DYSON ESTATES SUBDIVISION, FIRST ADDITION, **RESUBDIVISION OF**

APPLICATION NUMBER 16 DATE May 19, 2005
APPLICANT Dyson Estates Subdivision, First Addition, Resubdivision of
REQUEST Subdivision

DETAIL SITE PLAN

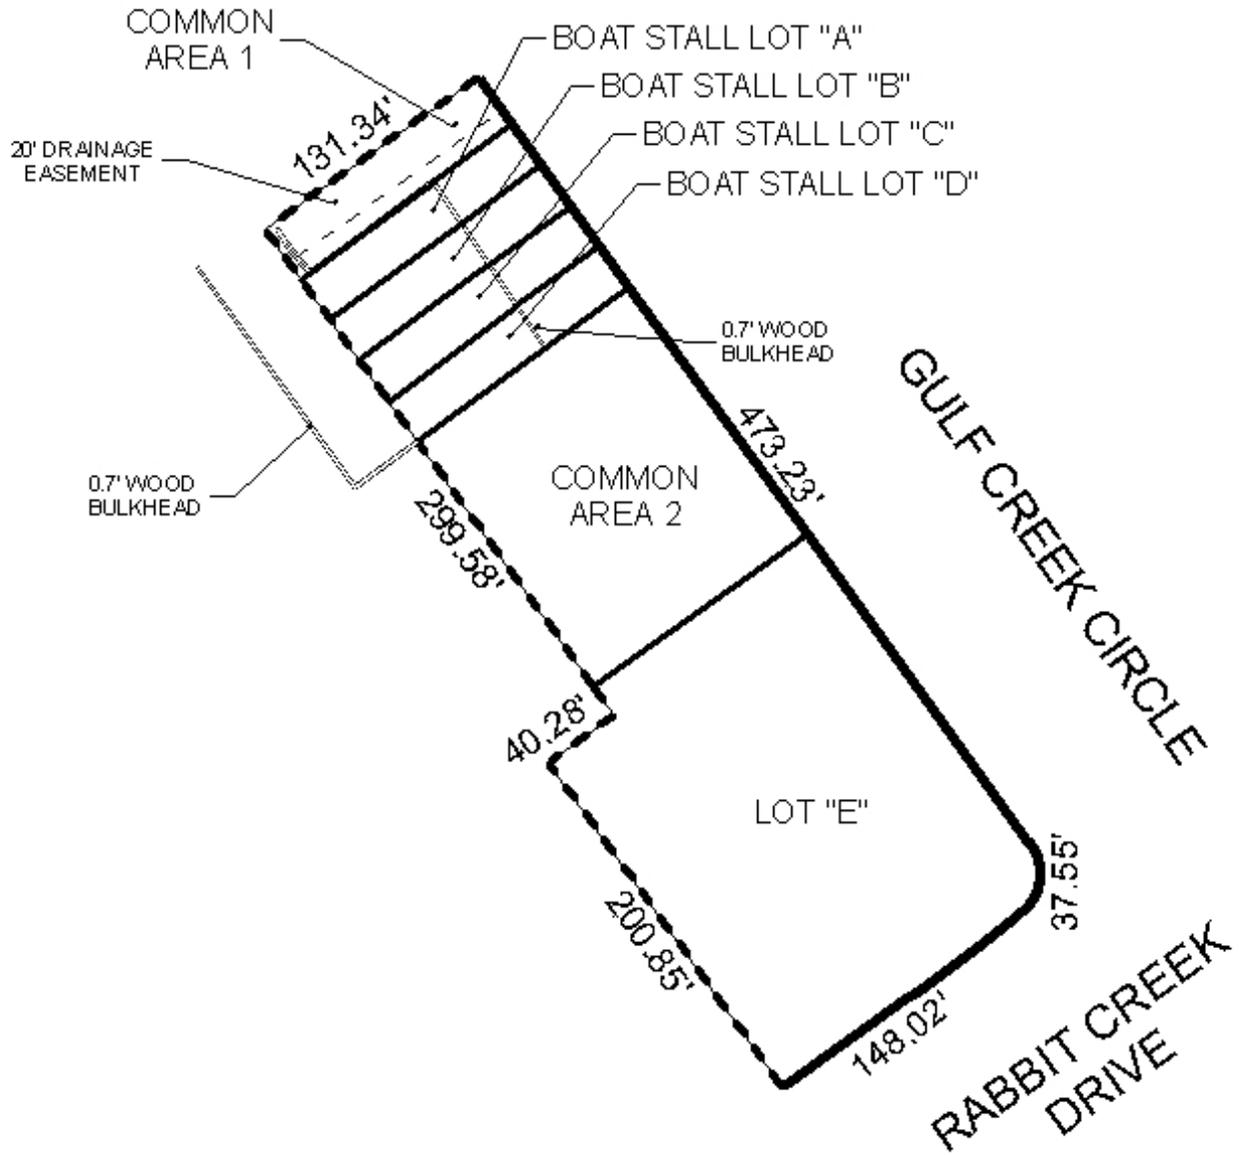
The site fronts Gulf Creek Circle, with a 50' right-of-way, and Rabbit Creek Drive, with a 60' right-of-way. The 25' minimum building setback lines are not shown, but would be required on the final plat.

While proposed Lot E would meet the minimum requirements, the proposed boat stall lots (Lots A through D) would each contain approximately 3275 square feet, considerably less than the minimum 7200 square feet required by the Subdivision Regulations for sites served by public water and sanitary sewer. The applicant brought a similar proposal before the Commission in 2000; the proposed lot configuration was recommended for denial because the site was not served by public sewer at the time, and the lots were less than the 15,000 square feet required for lots served by public water and individual septic systems; instead the applicant subdivided into two lots meeting the minimum size requirements. While the present application features lots substandard in size, there is sufficient common area to provide, on average, more than 7200 square feet per lot overall. As the site is now served by sanitary sewer, the reduced individual lot sizes no longer present sanitation issues.

The four boat stall lots would also be substandard in width, although they each have 25 feet of street frontage. The site as proposed could present significant access management concerns along Gulf Creek Circle, as there could be as many as five curb cuts within 130 feet of street frontage.

Based on the preceding, this application is recommended for denial for the following reasons: 1) the proposed lots are substandard in size and width; and 2) the arrangement of lots could present significant access management concerns along Gulf Creek Circle.
